July 6, 2021

Blake Adams
Manager
Office of Waste Diversion
DC Department of Public Works
202-359-2996
blake.adams@dc.gov

I write you on behalf of Energy Justice Network and the co-signed organizations below to express serious concern about the process and substance of the “Waste-to-Energy (sic) vs. Landfill Study” that DPW has hired CDM Smith to conduct.

⁹ Chart from EPA Dioxin Reassessment Summary 4/94 - Vol. 1, p. 37 (Figure II-5. Background TEQ exposures for North America by pathway)

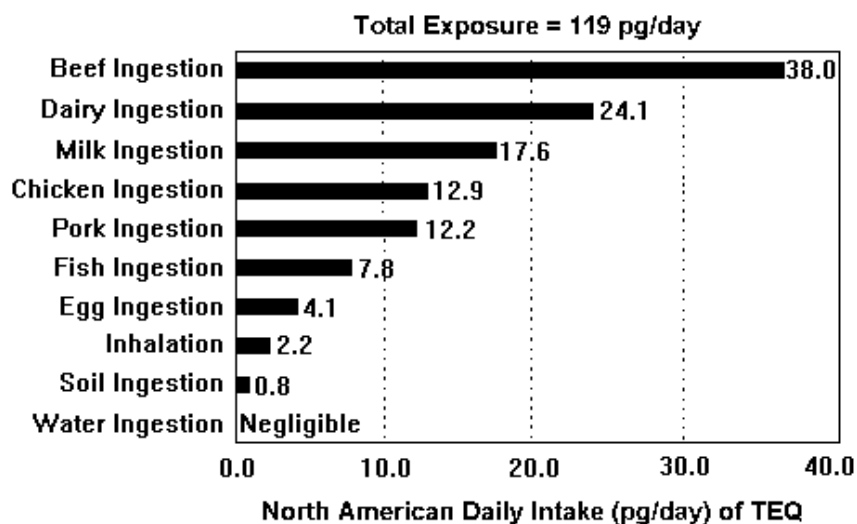
The following chart is from EPA's 1994 draft dioxin reassessment (final report never completed).⁹ It shows where a person eating a typical North American diet will get their dioxin exposure. Inhalation pales in comparison to meat and dairy consumption, yet CDM Smith wants to assume inhalation is the only pathway worth studying because others are negligible.
